**DESIGN OF FIRE SPRINKLER SYSTEM
FOR THE TECHNICAL EDUCATION SHOPS AT
OLIVER WOLCOTT REGIONAL VOCATIONAL TECHNICAL
HIGH SCHOOL
TORRINGTON, CONNECTICUT
PROJECT: BI- RT- 853**

ADDENDUM NUMBER 1

November 14, 2011

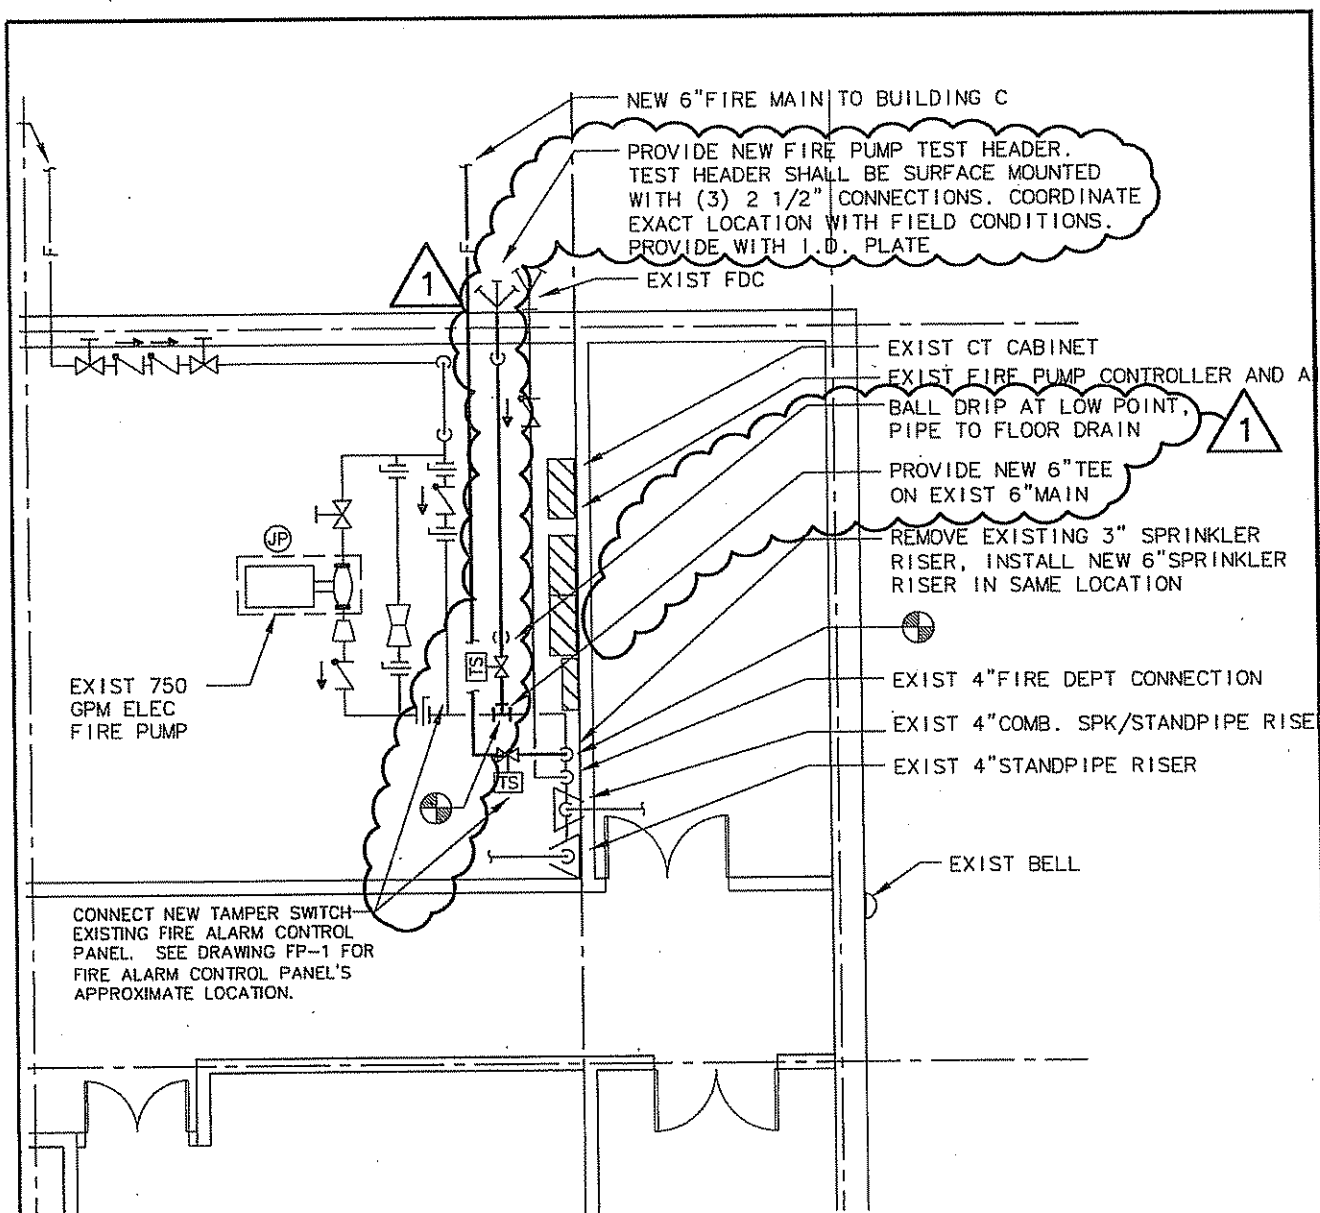
Drawing FP-4, FIRST FLOOR AREA G AND PARTIAL BASEMENT AREA B FIRE PROTECTION PLANS, dated June 23, 2010, **REVISE** the drawing as indicated on the attached sketch SKFP-2.
